Memorandum

Reference number
229841

Subject **3 Bank St Pyrmont - Review of Traffic Impact Assessments**

Figure 5. McLaren vehicle swept path analysis – entry to site

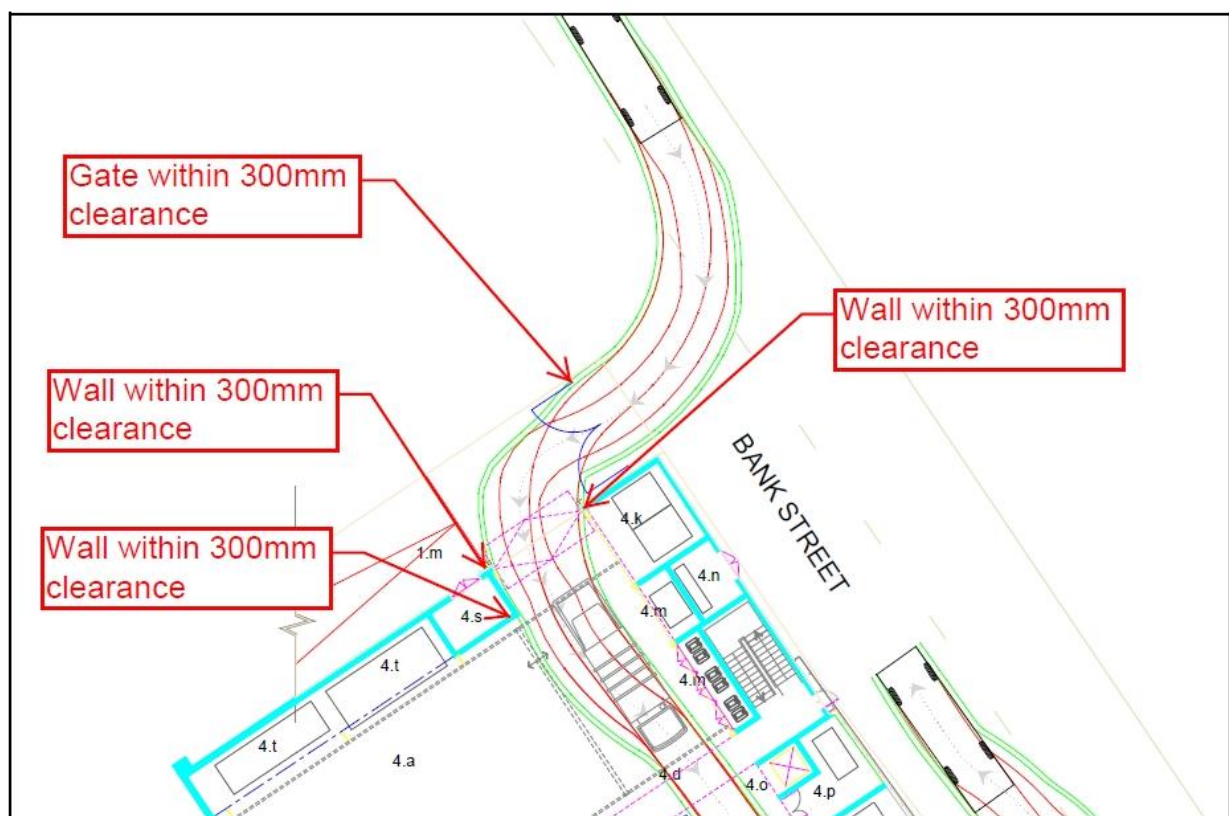
Arup notes the following issues with the swept path diagrams provided in Annexure F of the McLaren TMAP report:

- Paths were completed for a vehicle speed of 3km/h which is slower than the 10km/h for circulation and 5km/h for manoeuvring that is outlined in AS2890.1 Appendix B;
- The 300mm circulation clearance is encroached in four locations on entry as shown in Figure 5;
- The path assumes vehicles approach from the north on Bank Street turning right into the development. Details are not provided for an approach with a left turn from the south on Bank Street, nor is it identified that this movement will be prohibited;
- No detail is provided on what appear to be speed humps on entry and exit to the servicing area and whether these are capable of being manoeuvred by MRV's;
- The exit path crosses onto the wrong side of the road on exit;
- There does not seem to be a designated loading bay.

We also note that if the truck parks in the narrow portion of the servicing area (the area marked for deliveries on SK41-A), then another vehicle cannot pass.

- The swept path analysis for medium rigid service vehicles provided in the McLaren TMAP is not consistent with the requirements of AS2890.1 Appendix B and indicates several deficiencies. The TMAP does not demonstrate that service vehicles can adequately access the development.
